Subject: MHI's Response to US-APWR DCD RAI No. 297-2287 Revision 2

MHI's Response to US-APWR DCD RAI No. 297-2287 Revision 2

**US-APWR Design Certification
Mitsubishi Heavy Industries
Docket No. 52-021**

RAI NO.: NO. 297-2287 REVISION 2
SRP SECTION: 15 – INTRODUCTION – TRANSIENT AND ACCIDENT ANALYSES
APPLICATION SECTION: 15.0.0
DATE OF RAI ISSUE: 5/04/2009

Figure 15.0.0-3.33 Reactor Power versus Time with and without LOOP Feedwater System Pipe Break - RCS Pressure Analysis

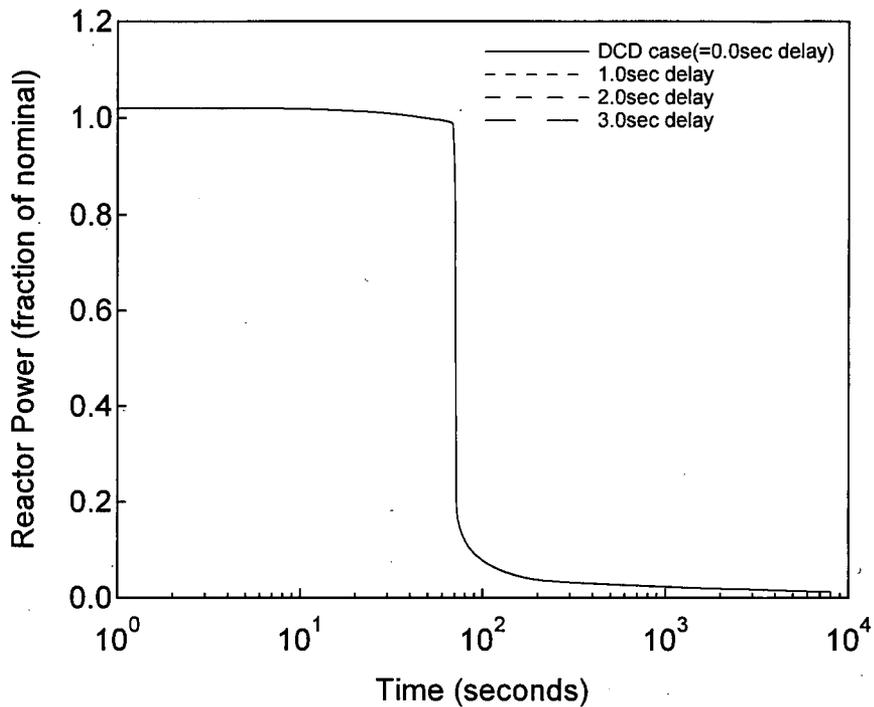
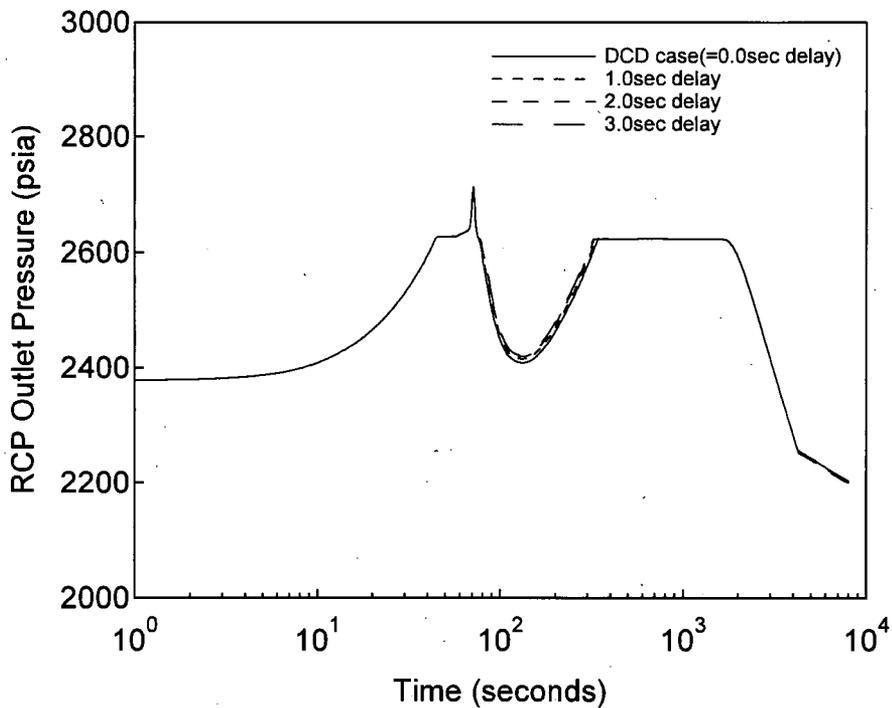
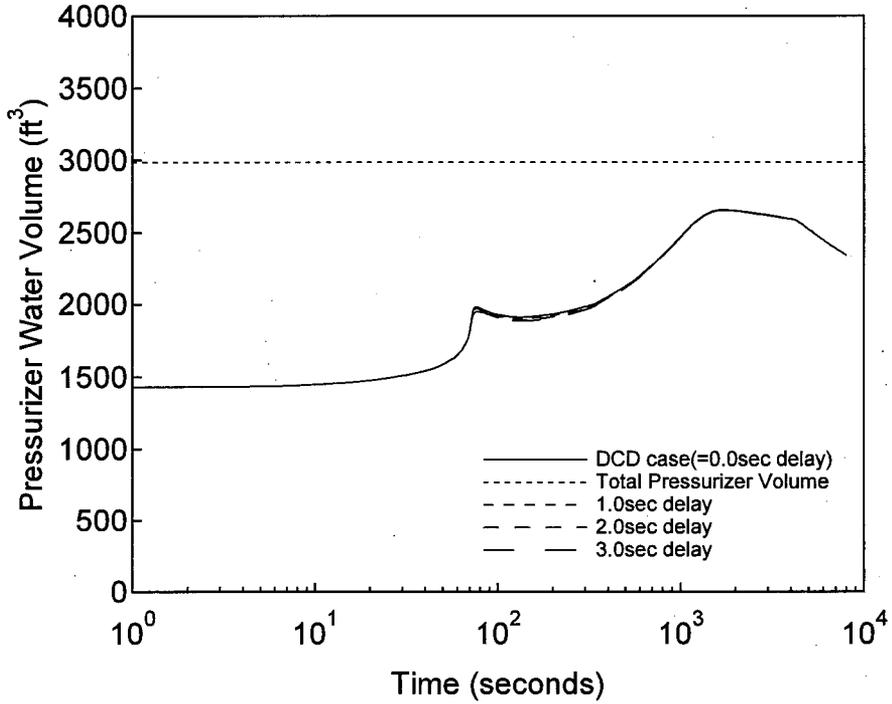
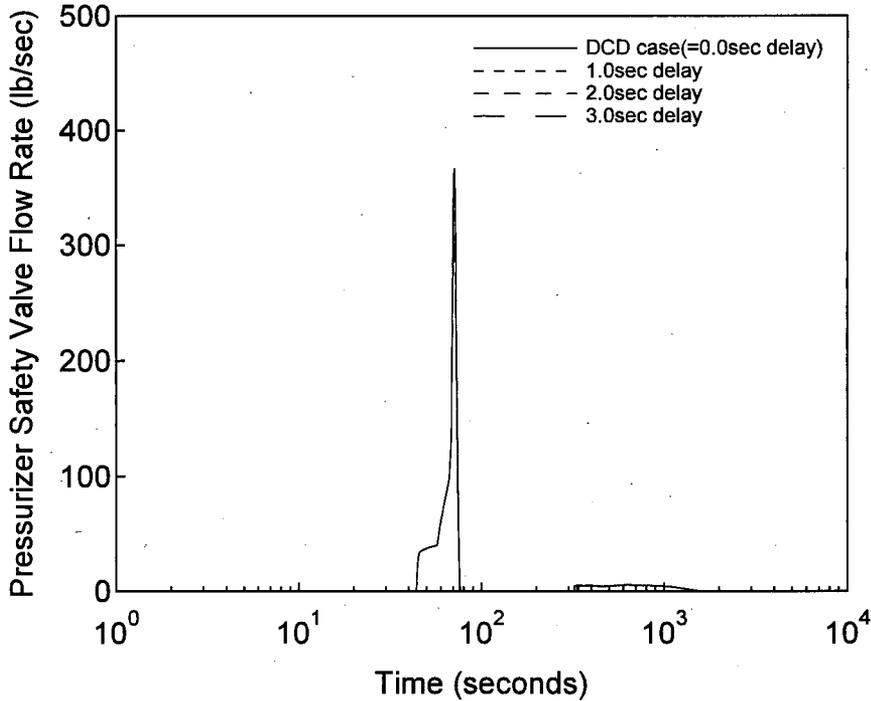
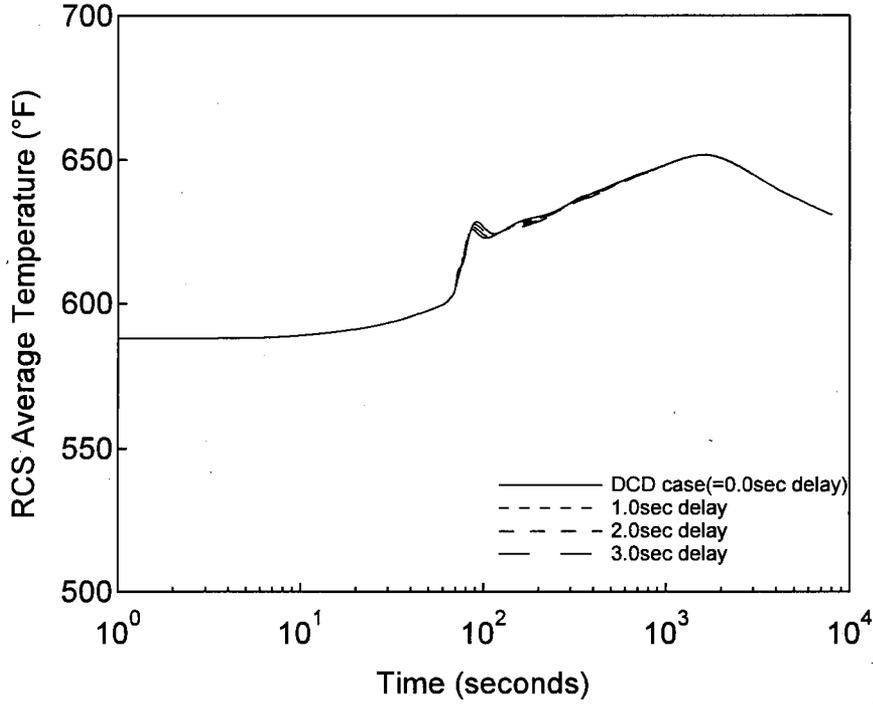
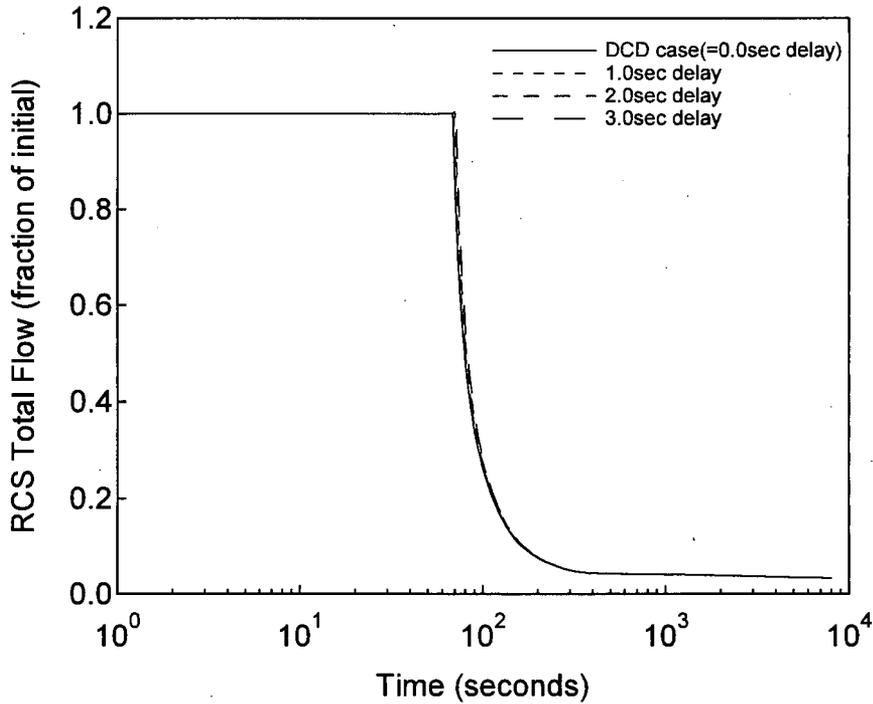
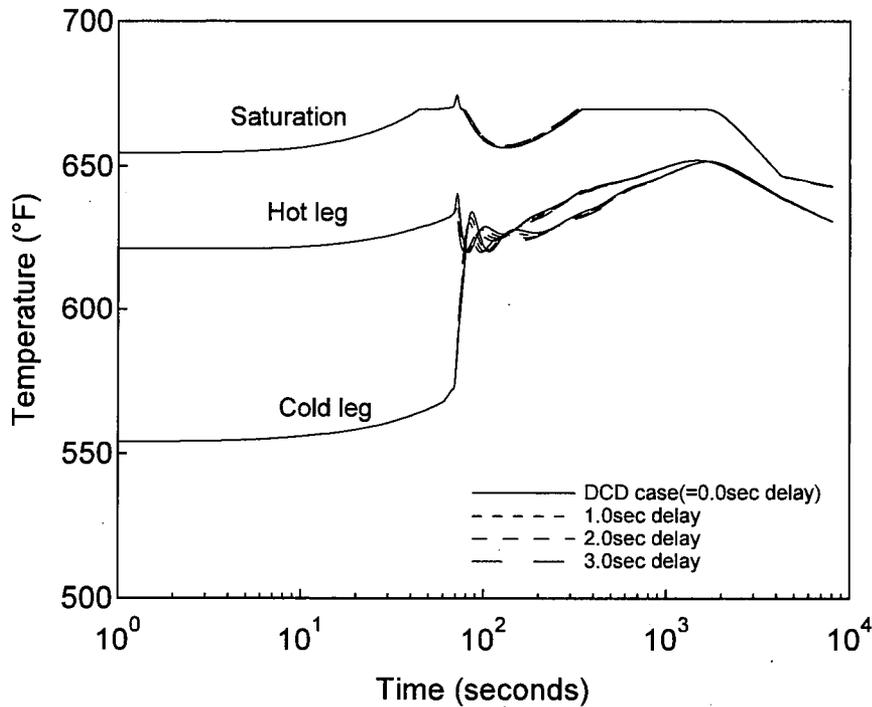
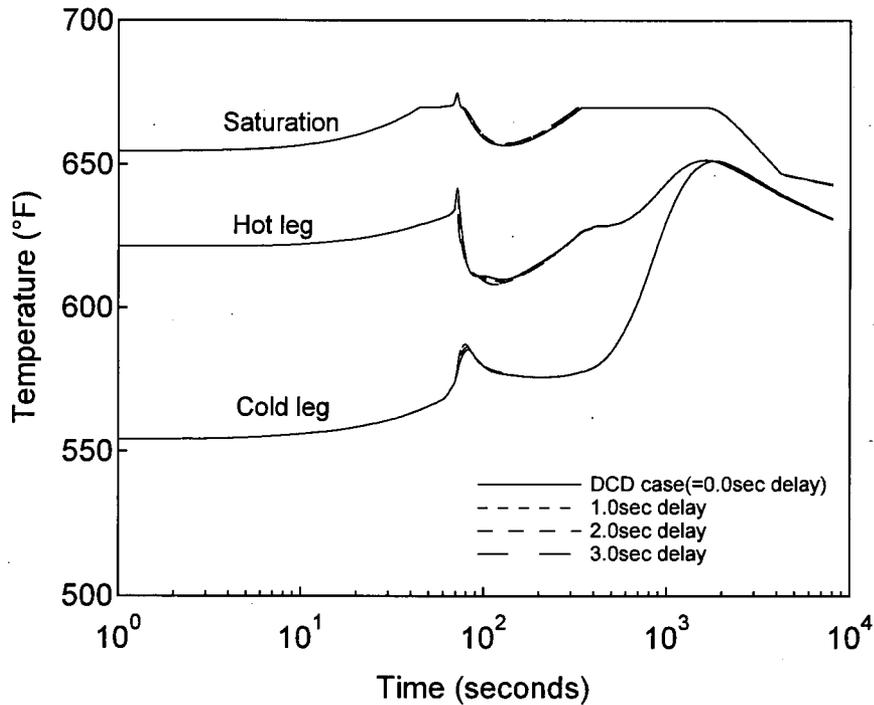
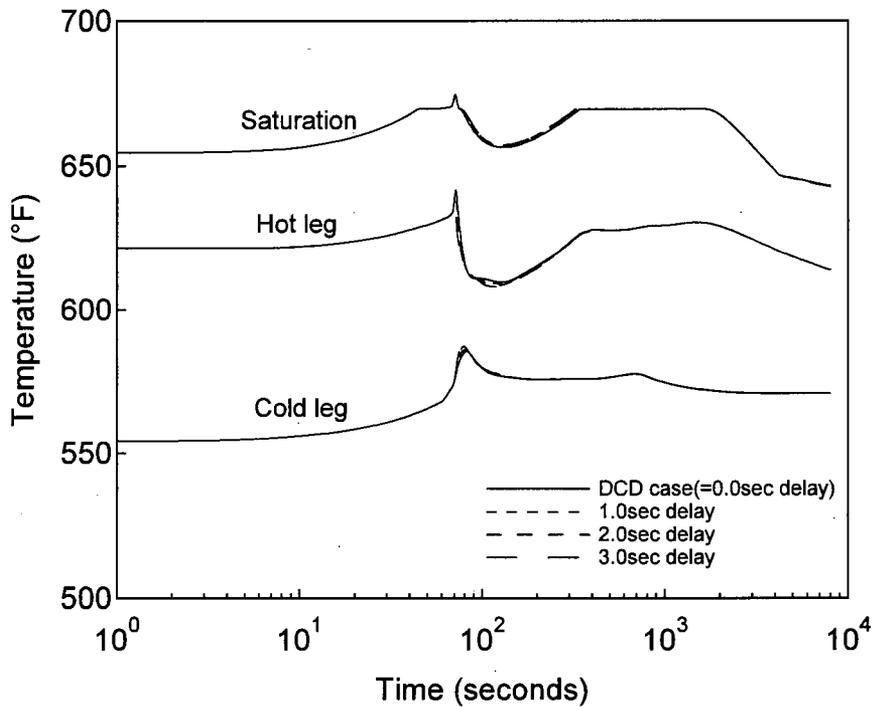
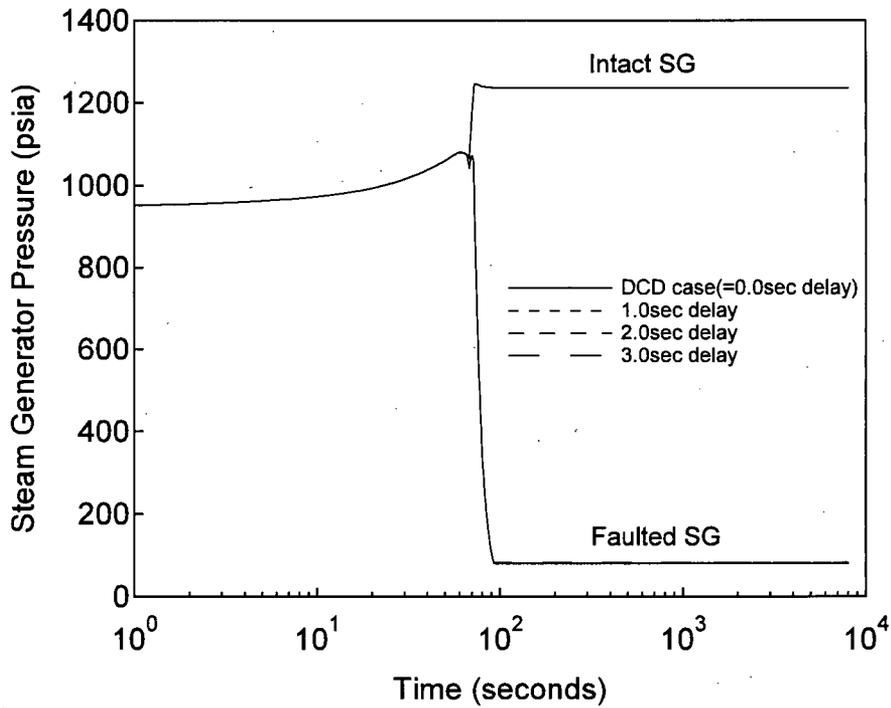
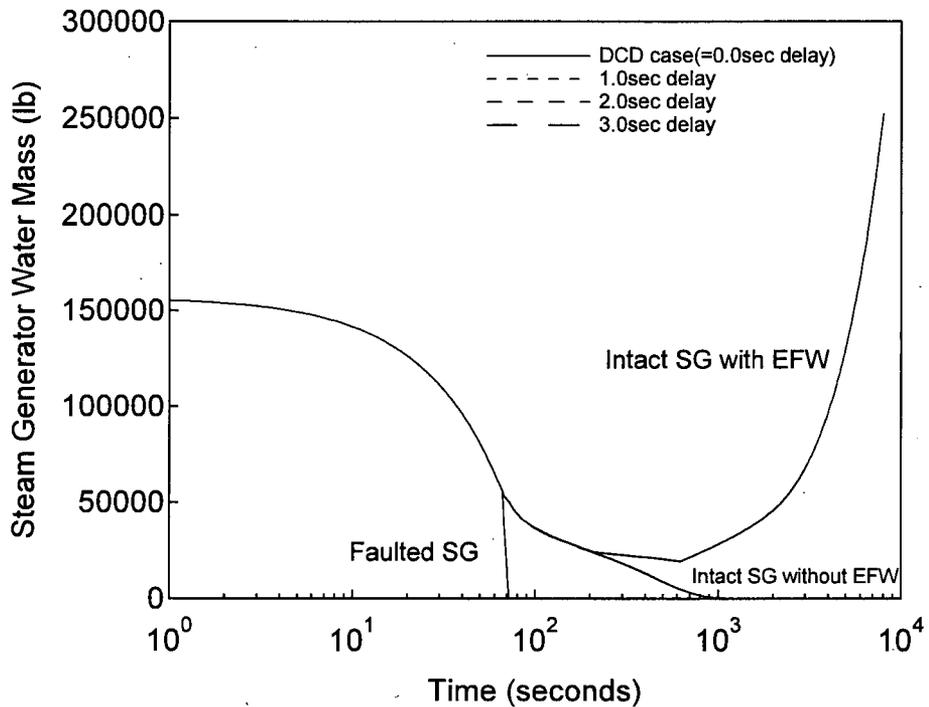
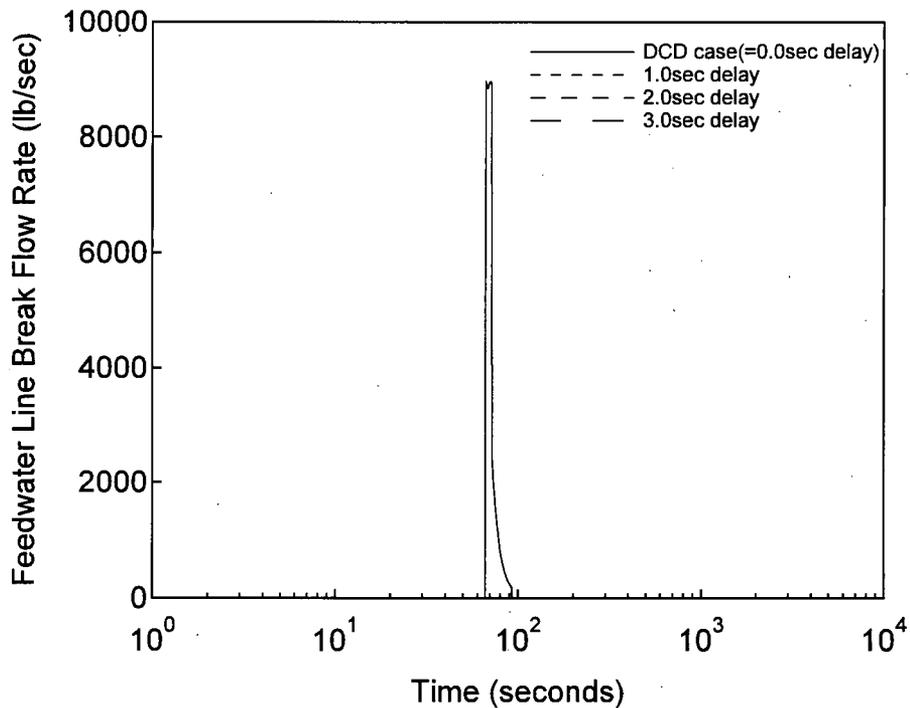
In DCD Section 15.0.0.7, the applicant presents arguments concerning the timing of a LOOP with respect to the timing of reactor trip and RCP coast down. By assuming a time delay in the onset of a LOOP, the onset of DNBR is decoupled from the availability of offsite power because the rods are inserted to the dashpot by the time the LOOP is initiated; therefore, the RCPs continue to run until the rods have been inserted in the core. This argument repeats itself throughout many Chapter 15 scenarios, allowing for the neglect of any LOOP consequences. Please provide more substantial arguments in defense of this assumed time delay, supported by sensitivity calculations that directly address this issue. (see also Question 15.1.2-1).

Two representative events were evaluated using MARVEL-M to assess the impact of the assumed LOOP delay time on the peak pressure: loss of load (Subsection 15.2.1) and feedwater line break (Subsection 15.2.8). Transient results for the key analysis parameters for the loss of load event with LOOP are provided in Figures 15.0.0-3.26 through 15.0.0-3.32. For the RCP outlet pressure shown in Figure 15.0.0-3.27, the cases with 2 and 3 second delay times have peak pressures that

are bounded by the DCD case, while the cases with 0 and 1 second delay times have slightly higher peak pressures than the DCD case. However, the difference in peak pressure is very small and in all cases, the peak pressures meet the relevant acceptance criteria. Transient results for the key analysis parameters of the feedwater line break event with LOOP are provided in Figures 15.0.0-3.33 through 15.0.0-3.44. It is important to note that the DCD feedwater line break case already assumes LOOP occurs with a 0 second (as opposed to a 3 second) delay time. The figures show that all parameters are mostly insensitive to the LOOP assumption. The relatively small differences in LOOP delay times are insignificant compared to the relatively long duration of the feedwater line break event. The DCD case shown in Figure 15.0.0-3.34 (which assumes a LOOP with 0 seconds delay) does have a slightly higher peak RCP outlet pressure than the other cases, but in all cases, the peak pressures meet the relevant acceptance criteria.

The results of the peak pressure analysis of these two events show that peak pressure is not as sensitive as DNBR to the LOOP assumptions. With a 3, 2, or 1 second delay between the turbine-generator trip and LOOP, the peak pressure is the same for the case with and without LOOP. The peak pressure is slightly higher for the 0 second delay case, but still within the acceptance criteria. Since the two events selected for this sensitivity analysis were the most limiting peak pressure events in Chapter 15, the remaining peak pressure analyses in Chapter 15 would also be adequate regardless of the assumptions about the LOOP delay time. While the results of this sensitivity analysis show that the DCD analyses meet the acceptance criteria, the description of the LOOP assumptions for peak pressure analyses in DCD Section 15.0.0.7 will be revised to more accurately describe the results of this sensitivity study.
